# International Aero Engines SERVICE BULLETIN

Subject: Transmittal of Revision 1 to Service Bulletin No.  
V2500-ENG-72-0208

**V2500-ENG-72-0208**

ENGINE - LP TURBINE ROTOR AND STATOR ASSEMBLY - INCORPORATE A REVISED  
TORQUING PROCEDURE FOR THE NO.5 BEARING REAR LOCK NUT

Install the turbine shaft rear lock nut  
Figure 1

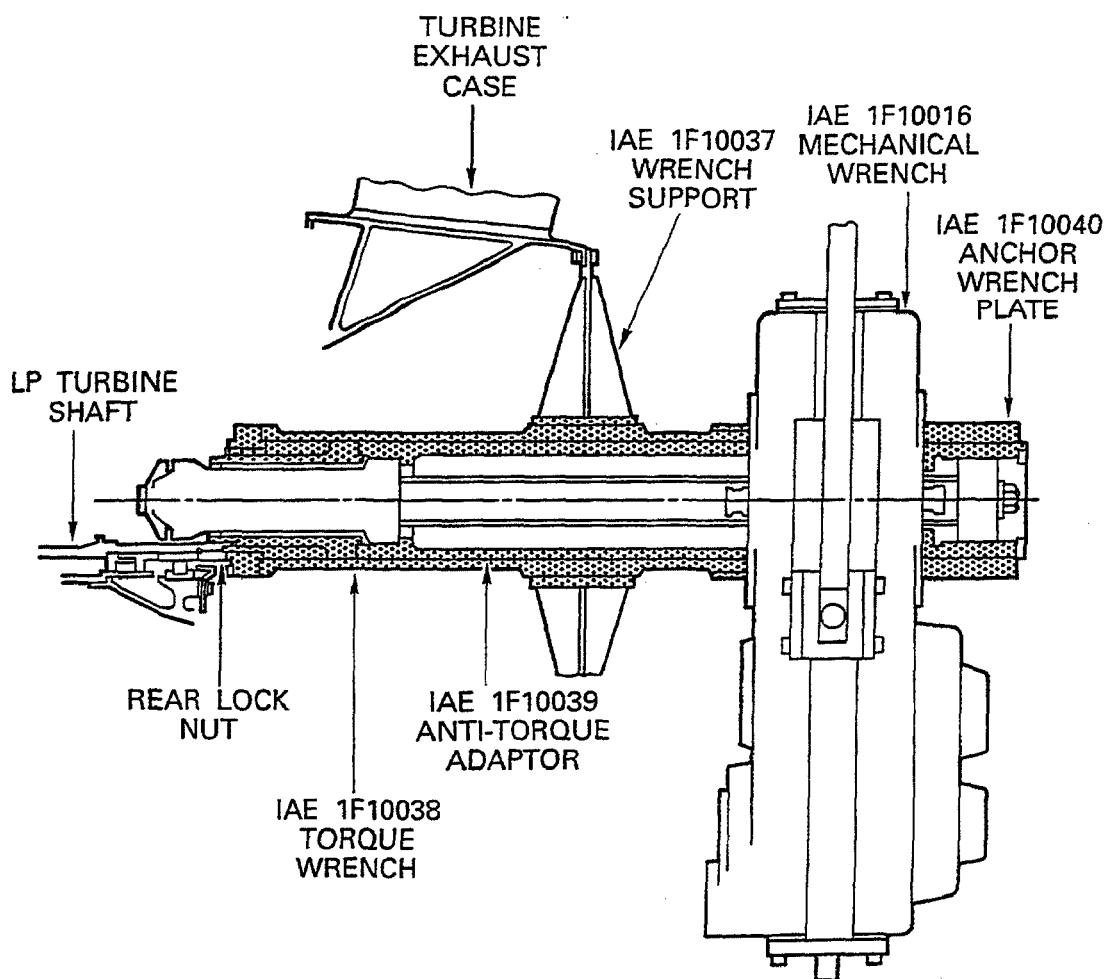
The loose stacking between LP turbine shaft and carbon seal spacers may cause oil leakage from the No.5 bearing compartment chamber. This problem can be solved by changing tightening method from torque-set method to angle-of-turn method for tightening the Rear Lock Nut.

- 5 Operate the mechanical wrench to release the rear lock nut.
- 6 Operate the mechanical wrench and torque the rear lock nut to 4000 to 6000 lbfin (452 to 678 Nm) .

- 7 Put an angle-of-turn of five to eight degrees to the rear lock nut.
- 8 Operate the mechanical wrench to release the torque until the torque value to zero.

- 9 Torque the rear lock nut to 4000 to 6000 lbfin (452 to 678 Nm) again.
- 10 Make a correlation mark between the IAE 1F10016 mechanical wrench and the IAE 1F10038 torque wrench.

- 11 Put an angle-of-turn of five to eight degrees to the rear lock nut.
- 12 Do step 8 again.
- 13 Do step 9 again and check the correlation mark. The correlation mark must be within two degrees maximum on the same place.

- 14 If the correlation mark within limit, apply last angle-of-turn of five to eight degrees to the rear lock nut and go to step 17.
- 15 If the correlation mark is out of limit, delete the correlation mark and do steps 10 to 13 again until correlation mark is within limit.

- 16 Apply last angle-of-turn of five to eight degrees to the rear lock nut.
- 17 Align the slot of the rear lock nut with the slot of the LP turbine shaft rear end. The alignment of the rear lock nut must be in torque direction.
